BISCN BASIN PROJECT

NRC DOCKET NO. 40-8745
SUA-1396

PROPOSED MODIFICATION

JULY 14, 1981

Fig. 2.2. Bison Basin Project mining plan. For a detailed view of first mining unit, see Fig. 2.3. Source: ER, Fig. 3.2-1.

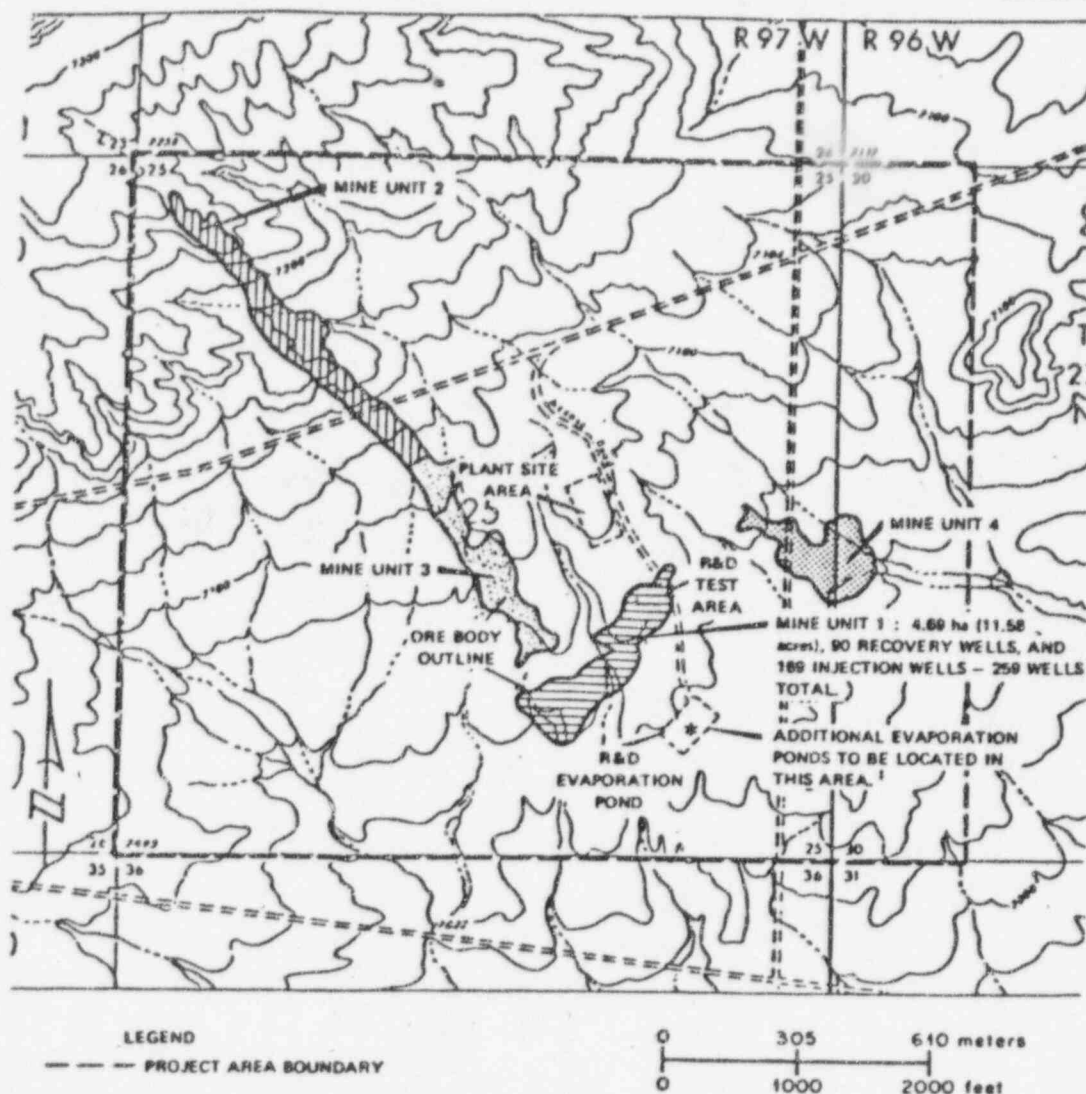
The mine plan submitted with the initial application partitioned the approximate 40 acre orebody into four units as depicted in the FES (Docket No. 40-8745), Figure 2.2, page 2-25 (see attachment 1). The four units were to be mined in the sequence shown in attachment 1.

The revised mine plan, based on the orebody outline presented in attachment 2 is shown on a map included with this document and identified as attachment 3. The mining sequence will be mining unit No. 1, mining unit No. 2 and mining unit No. 3. The surface areas of these three units are 29 acres, 25 acres and 21 acres; respectfully.
